**Re: Project, Permit No. M-1980-244;
Technical Revision (TR-121) Preliminary Adequacy Review**

The Division of Reclamation, Mining and Safety (DRMS) received a request for a Technical Revision (TR-121) addressing the following:

75 foot increase to the approved backfill elevation of the WHEX pit, and a lateral, 80 million ton storage increase of the ECOSA

<div><div>1" : 525'</div><div></div></div>	
Newmont Mining Co	Cripple Creek & Victor
TITLE:	Approved Topo
DATE:	2020/05/03
SCALE:	Y = 1" : 525'
Designed By:	Ryan Meany - Sr. Long Range Engineer
Signature:	<i>Ryan Meany</i>
Date:	2020/05/03

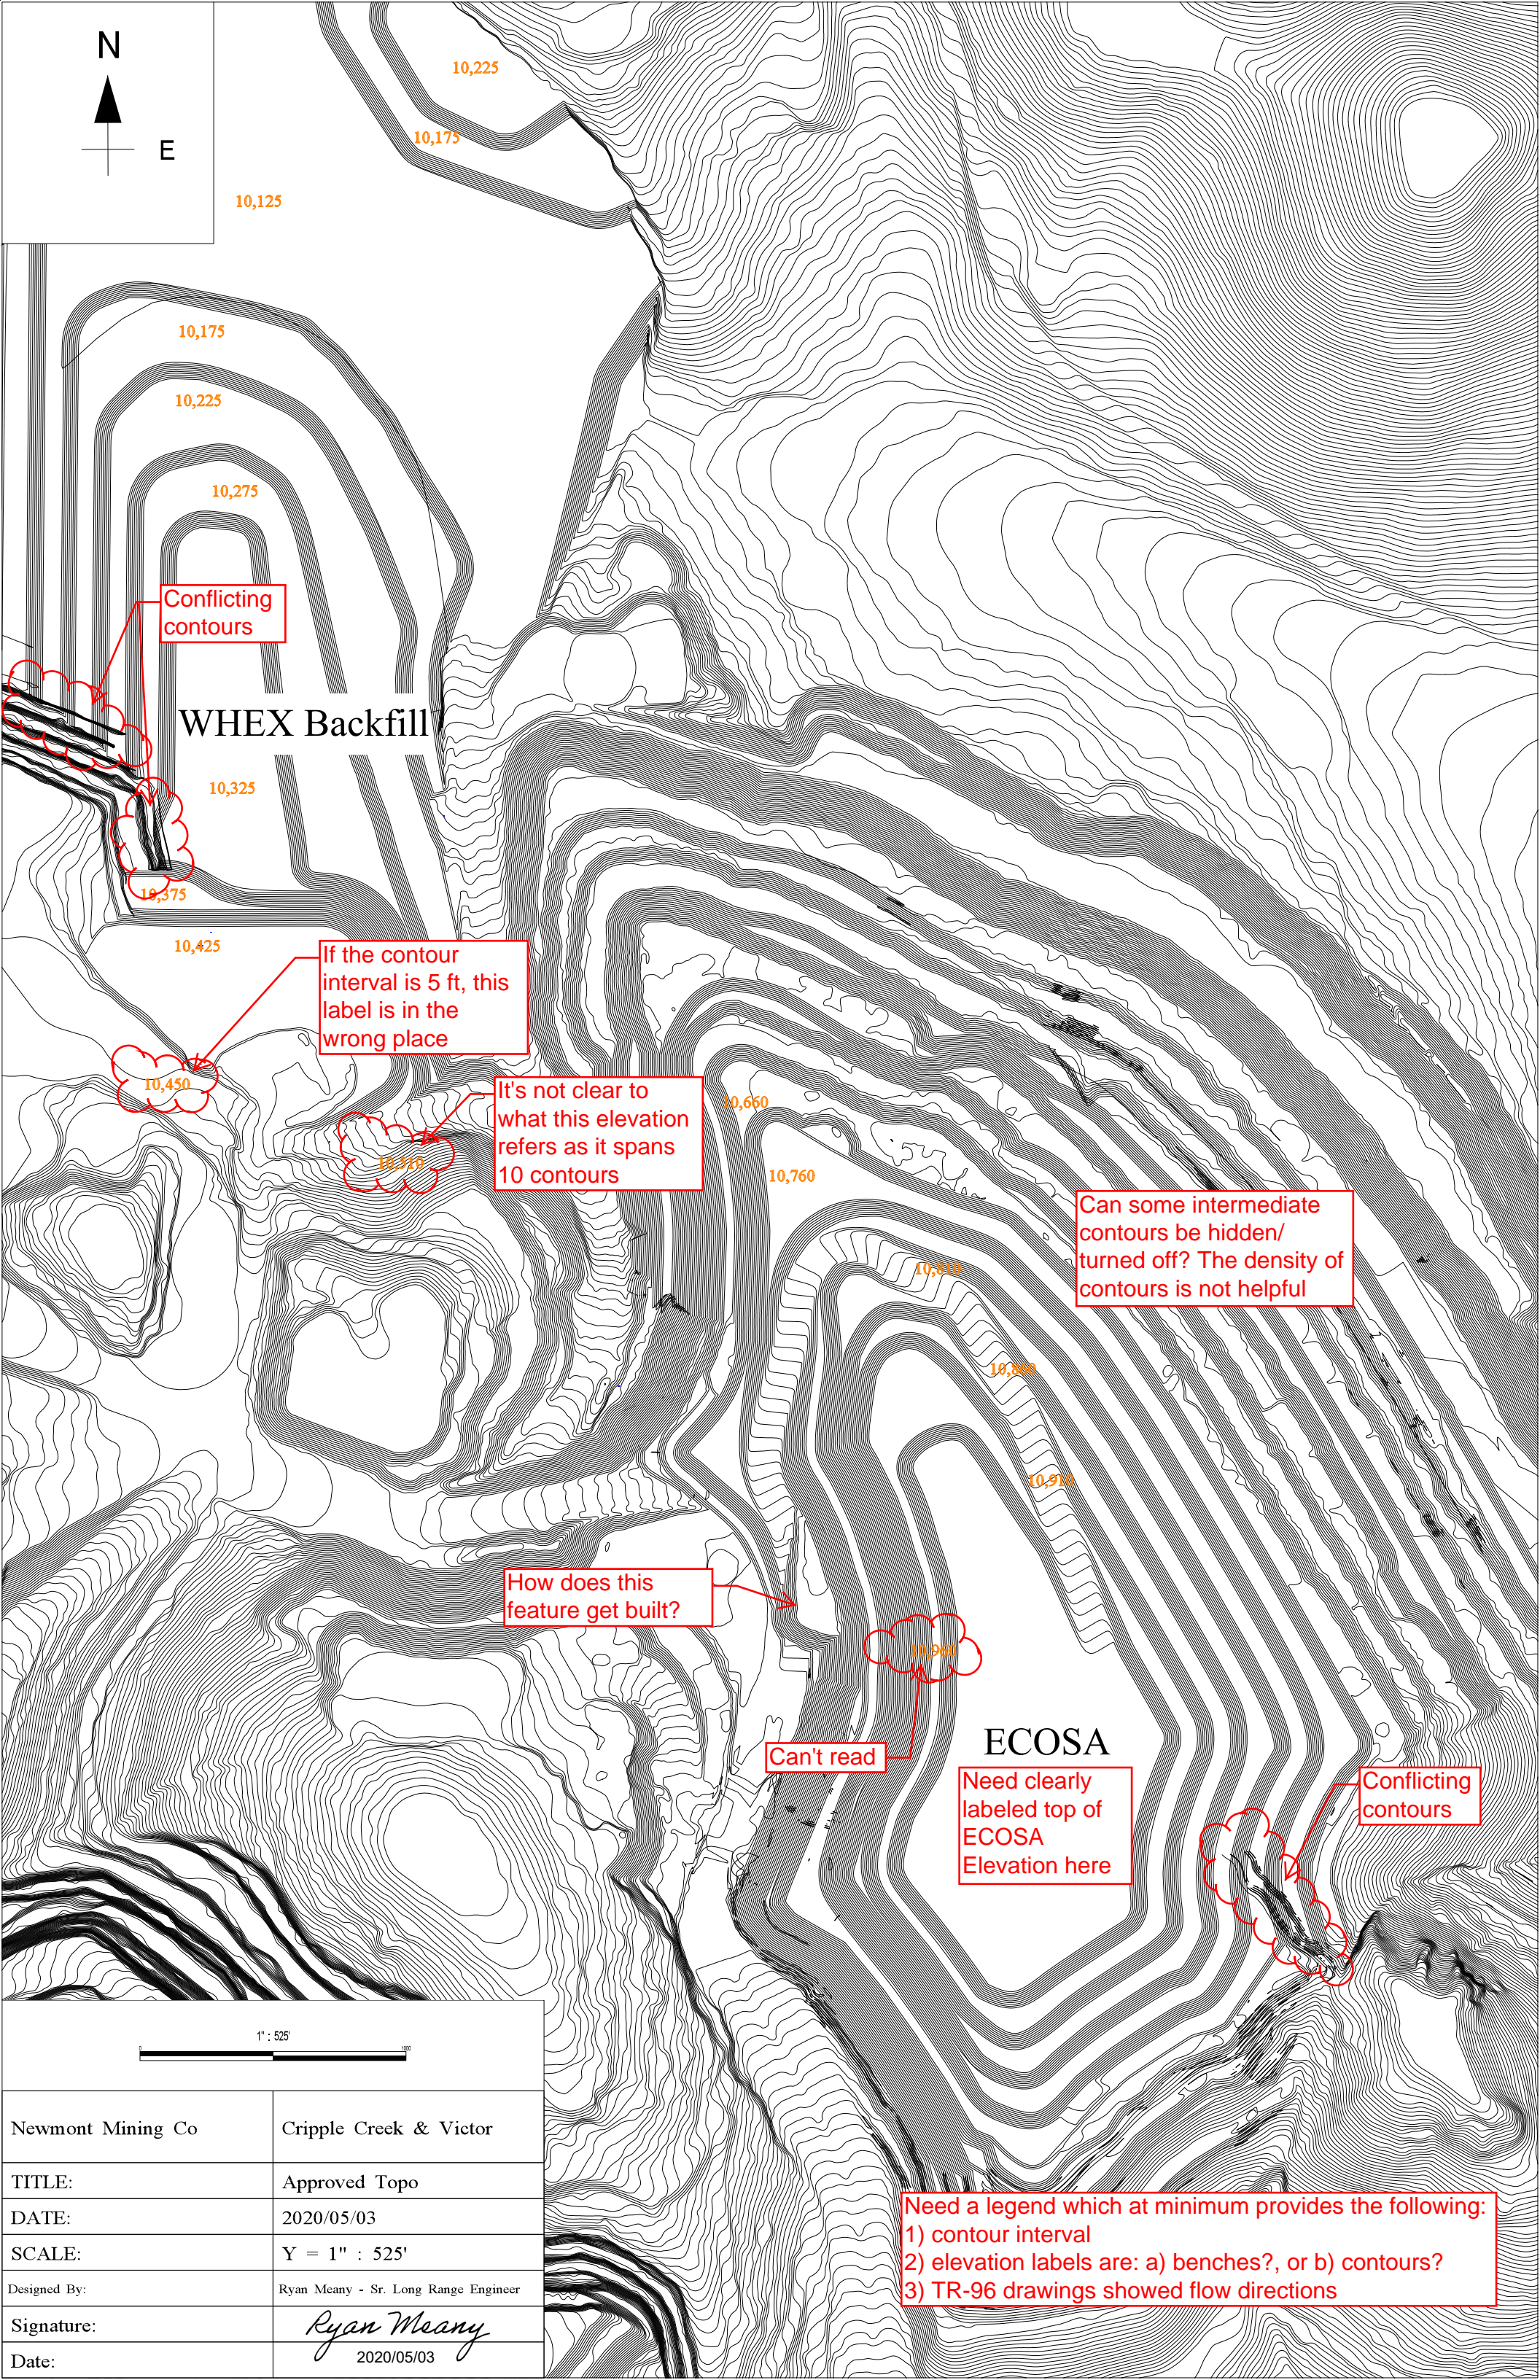
Conflicting contours

If the contour interval is 5 ft, this label is in the wrong place

It's not clear to what this elevation refers as it spans 10 contours

Can some intermediate contours be hidden/turned off? The density of contours is not helpful

How does this feature get built?

Can't read

ECOSA
Need clearly labeled top of ECOSA
Elevation here

Conflicting contours

Need a legend which at minimum provides the following:
1) contour interval
2) elevation labels are: a) benches?, or b) contours?
3) TR-96 drawings showed flow directions

Newmont Mining Co	Cripple Creek & Victor
TITLE:	Proposed Topo
DATE:	2020/05/03
SCALE:	Y = 1" : 525'
Designed By:	Ryan Meany - Sr. Long Range Engineer
Signature:	<i>Ryan Meany</i>
Date:	2020/05/03

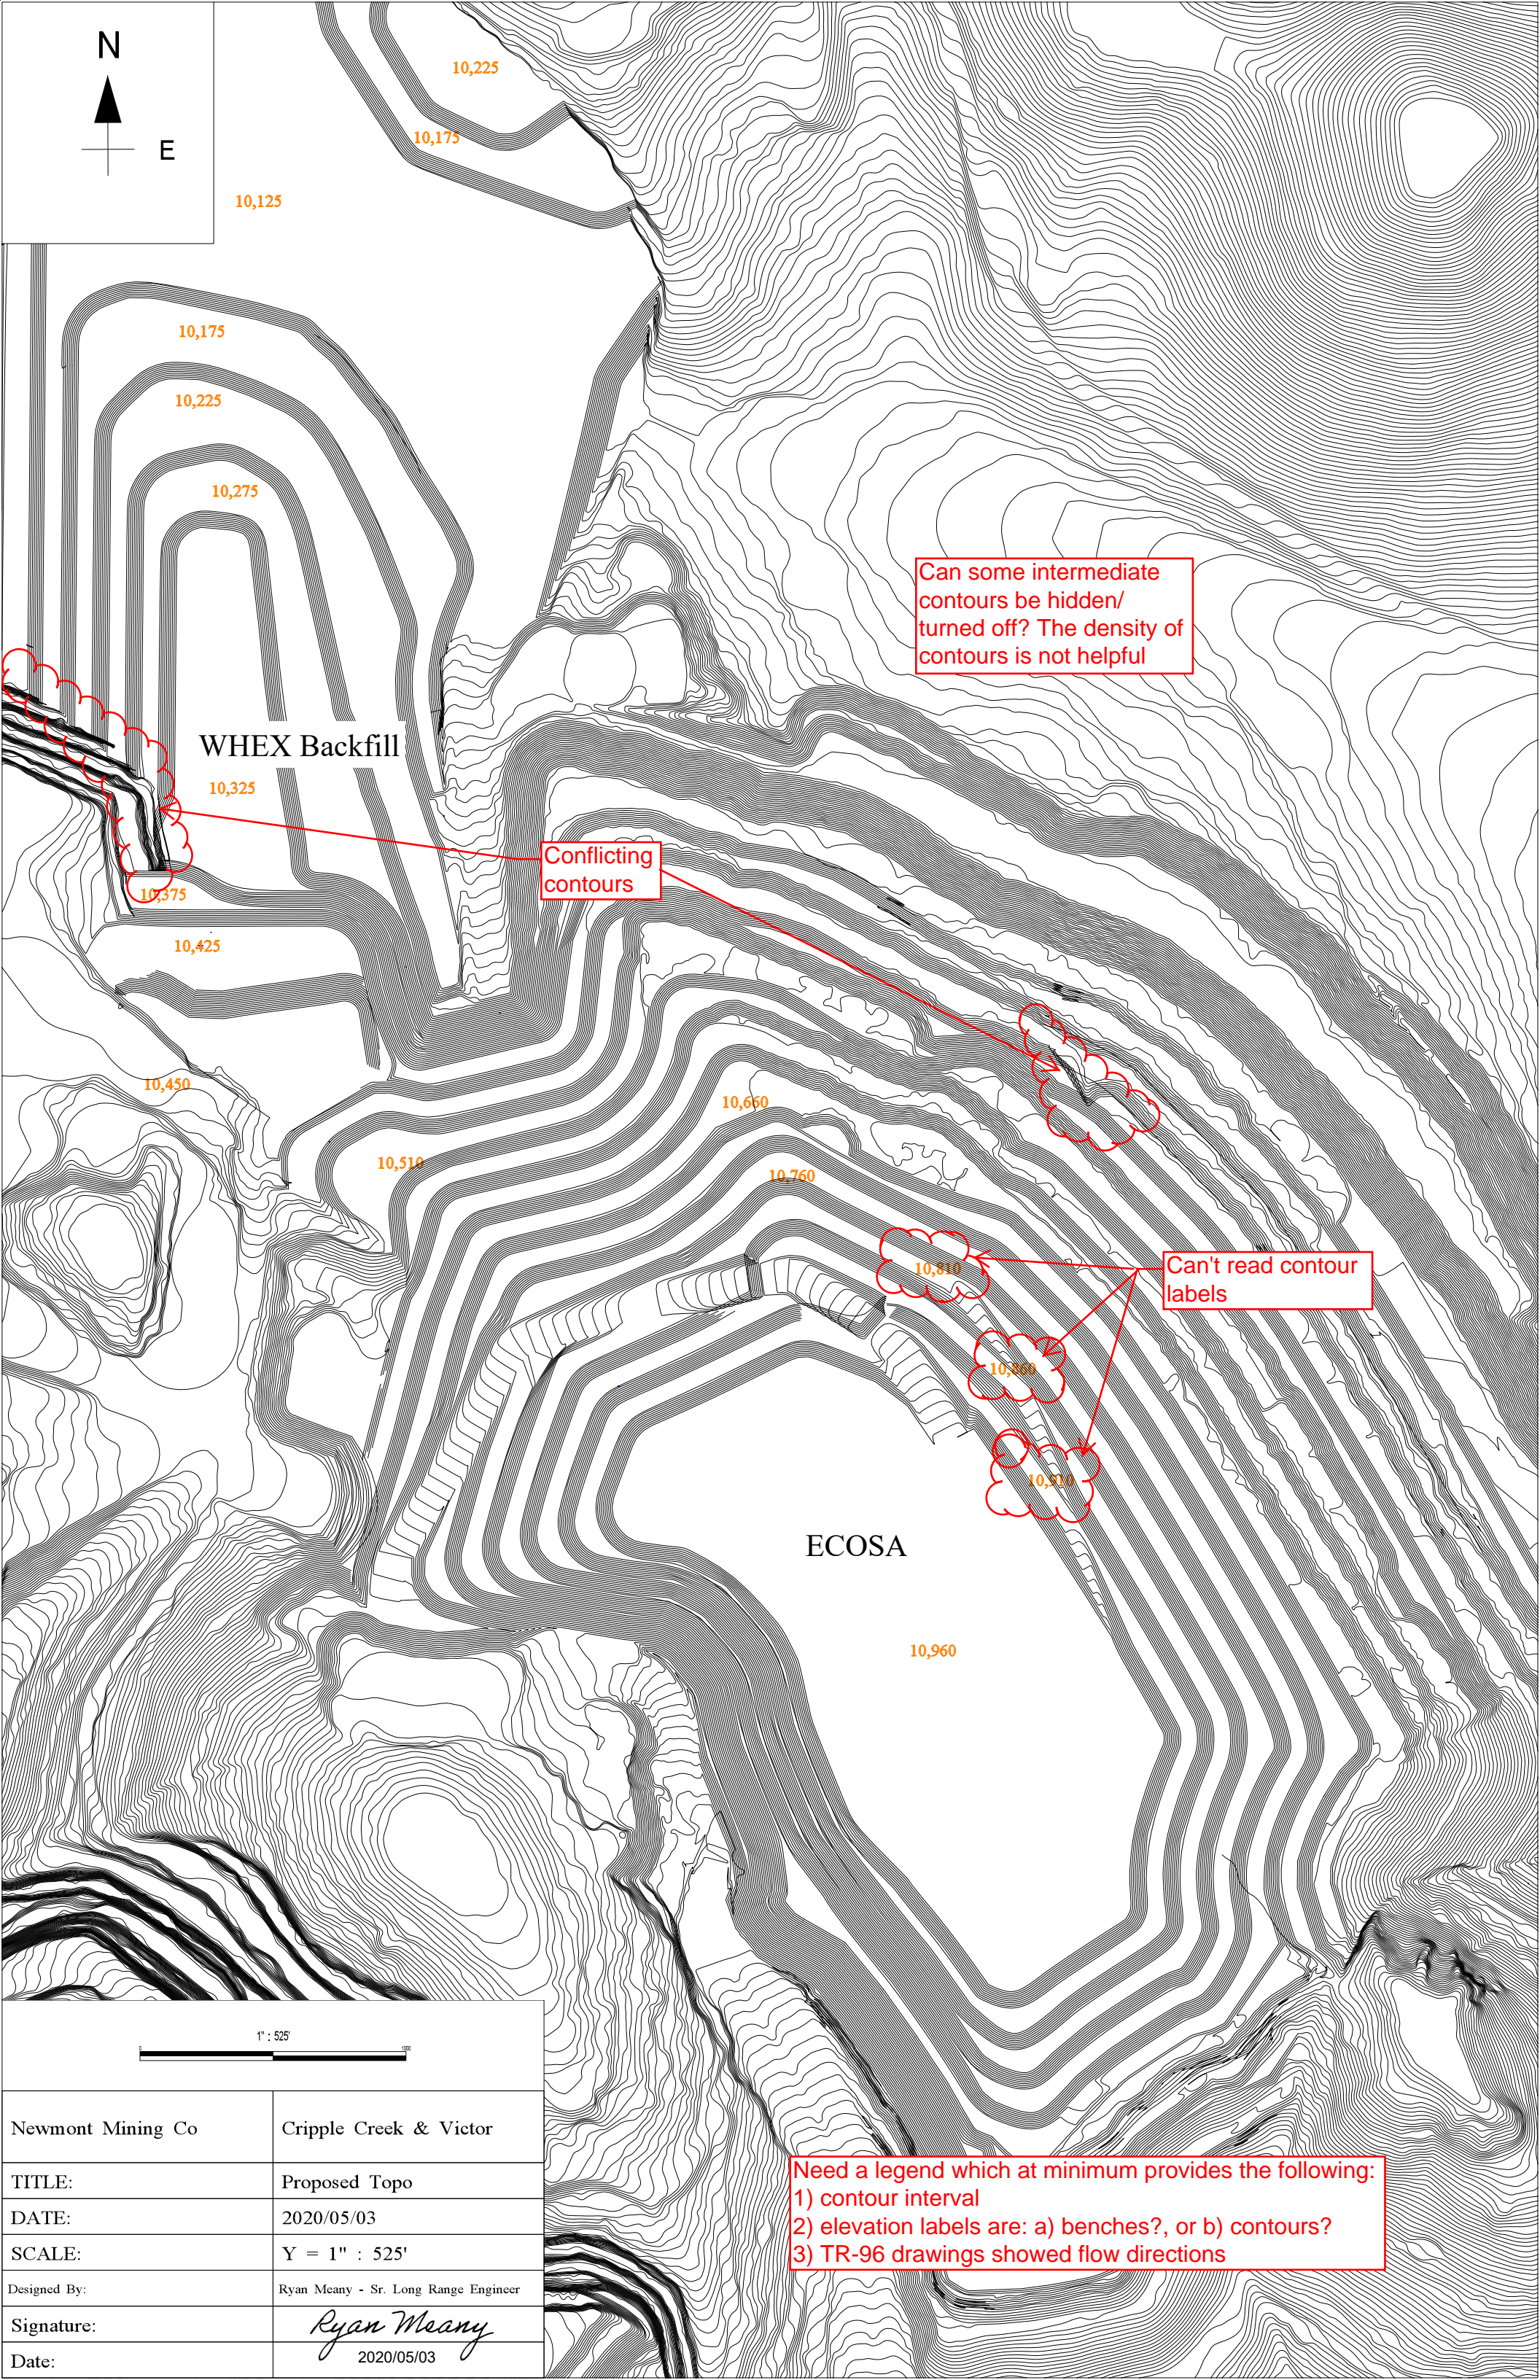
Can some intermediate contours be hidden/turned off? The density of contours is not helpful

Conflicting contours

Can't read contour labels

Need a legend which at minimum provides the following:
1) contour interval
2) elevation labels are: a) benches?, or b) contours?
3) TR-96 drawings showed flow directions

Newmont Mining Co	Cripple Creek & Victor
TITLE:	Post Mining Topo
DATE:	2020/05/03
SCALE:	Y = 1" : 525'
Designed By:	Ryan Meany - Sr. Long Range Engineer
Signature:	<i>Ryan Meany</i>
Date:	2020/05/03

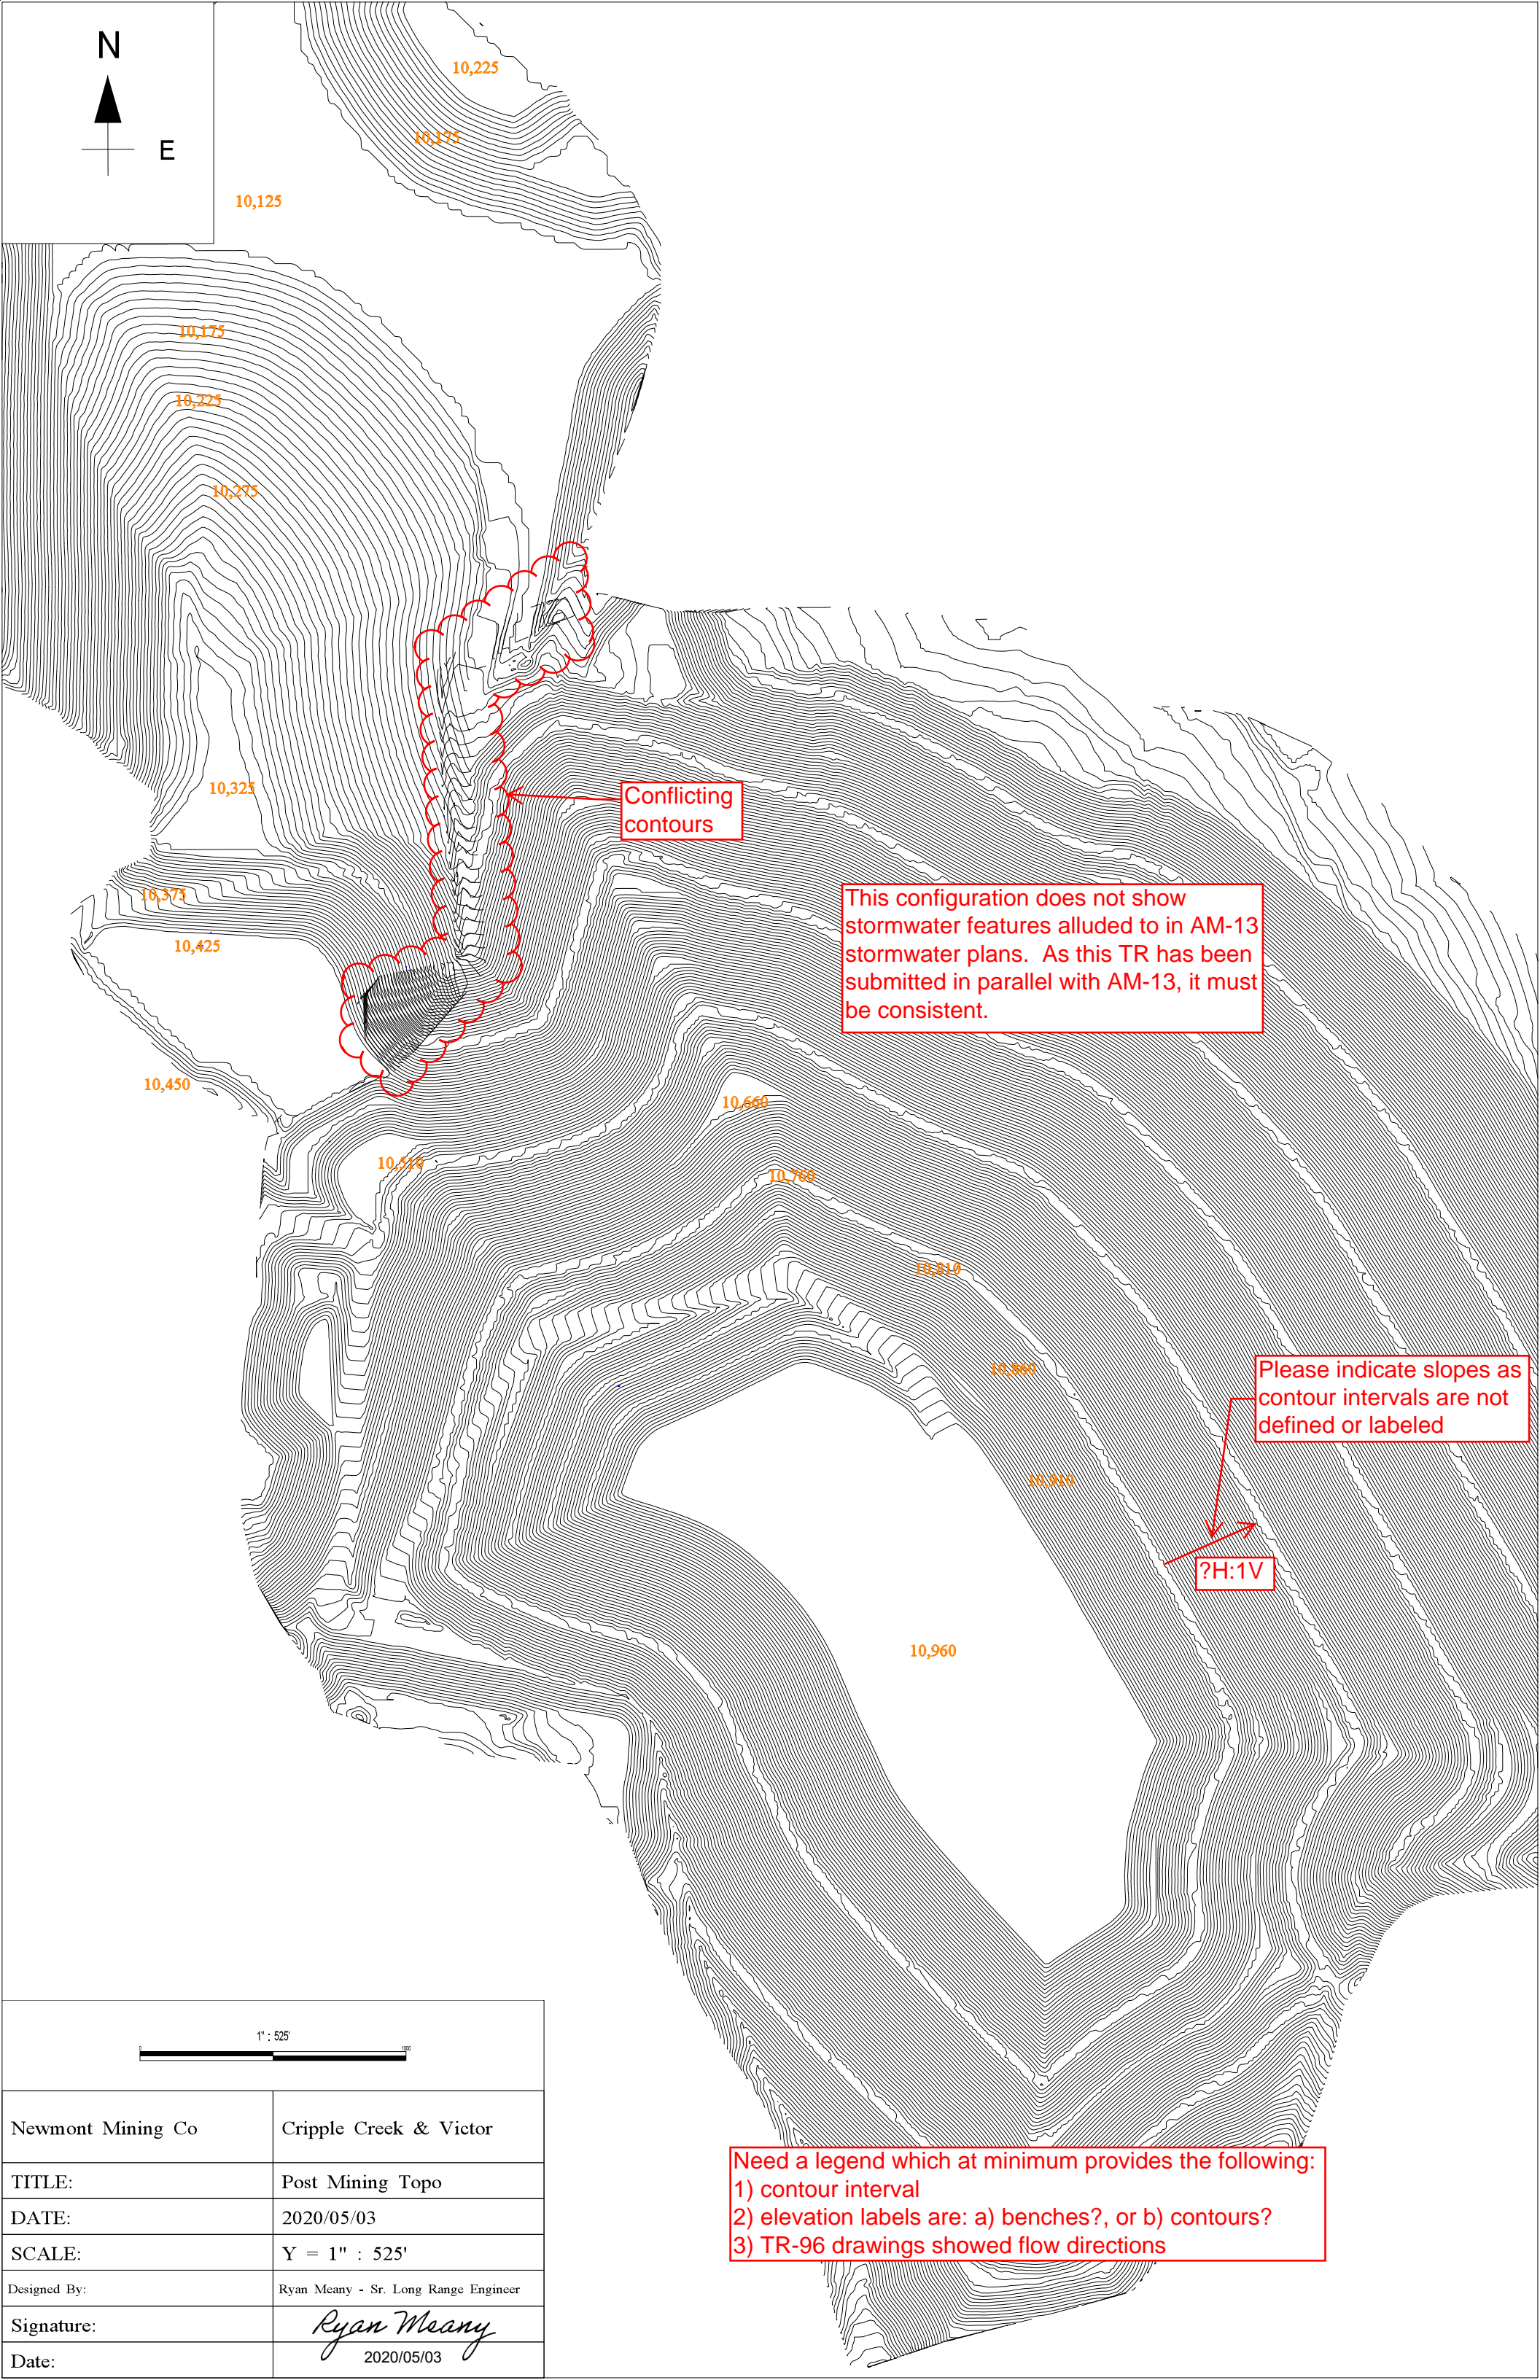
Need a legend which at minimum provides the following:
1) contour interval
2) elevation labels are: a) benches?, or b) contours?

Need a legend which at minimum provides the following:
1) contour interval
2) elevation labels are: a) benches?, or b) contours?
3) TR-96 drawings showed flow directions
